Dental Products Service Bulletin Number: D100

Subject: Lamp Shield (Birdcages) falling out of Model L lighthead after customer changes bulb or cleans reflector cover.

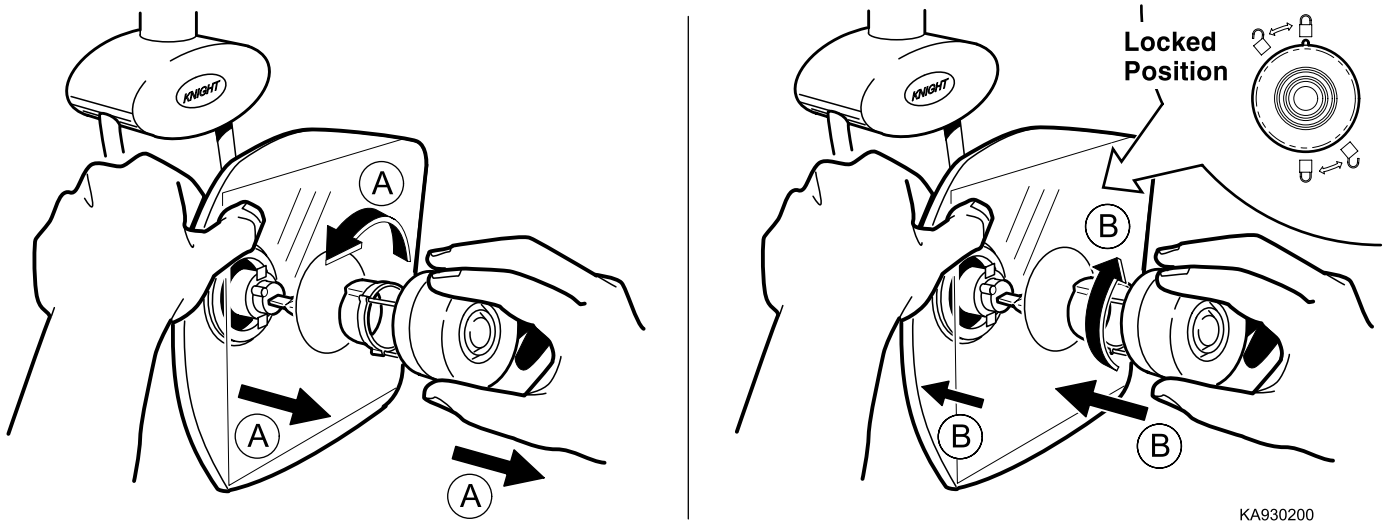
This kit pertains to Model L Dental Light.
The new lamp shield contains an embossed alignment designation and the new reflector cover has Unlock / Lock graphic designations.
With the new parts installed the Operator will be able to assure when the lamp shield is in the locked or unlocked position by where the lamp shield designation is aligned to the graphic designations on the cover.

A. While holding the reflector cover in position, push in and rotate the lamp shield *counter-clockwise* until it stops. Pull outward to remove the lamp shield and reflector cover.

B. Place the new reflector cover in position and insert the lamp shield. While pressing inward, rotate the shield *clock-wise* toward the LOCK graphic until the designator on the reflector is aligned with the graphic.

Pull outward on the lamp shield to assure it is locked in position.
